La Plata West Water Authority

RAW WATER PROJECT

ADDENDUM NO. 1

November 18, 2015

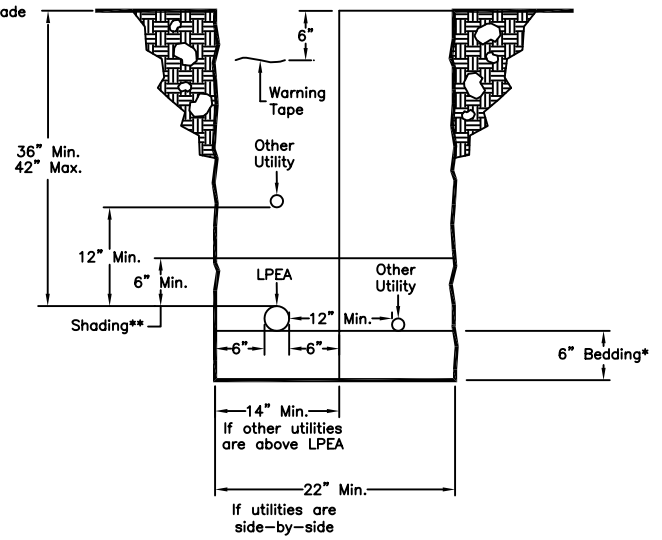
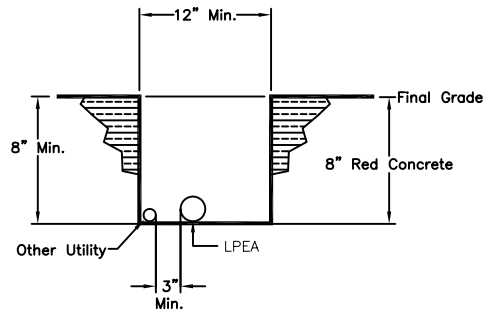
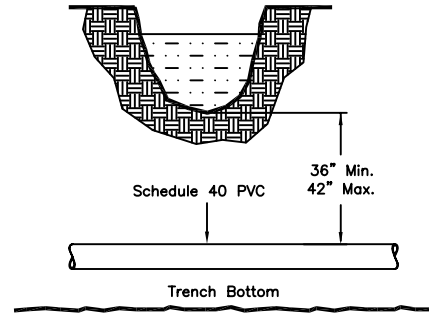
- F. Electric trenching and backfill is now included in Contract 1, Bid Package 3, Item 13. The trench for primary electric service shall be constructed on offset stationing 5' East from the transformer pad at the intake to Sta 0+00, 5'E to Sta 40+00, 5'E, then continuing to the location near the booster station where LPEA transfers from overhead power to buried power. Alternately, the contractor may provide a bench along the east edge of the waterline trench for electric service installation, provided the benched trench meets LPEA trenching standards. Utility will install electric cable in trench prior to backfill by contractor. Trench standards are provided as an attachment to this addendum. Measurement and Payment for this item will be per linear foot of trench, excavated and backfilled. Rock excavation for this item will be subsidiary to trench excavation.
